Economic and Social Council

Proposal for Supplement 25 to the 02 series of amendments to UN Regulation No. 30 (Tyres for passenger cars and their trailers)

Submitted by the Working Party on Noise and Tyres*

Annex 3,

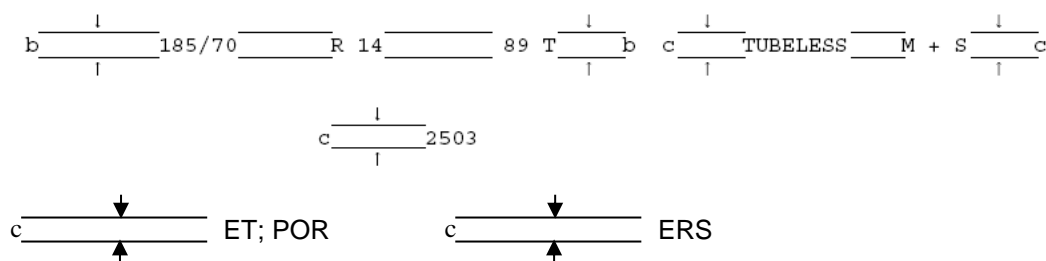
Paragraph 1., replace the figure by the following:

b = 6 mm (min.)
c = 4 mm (min.)"
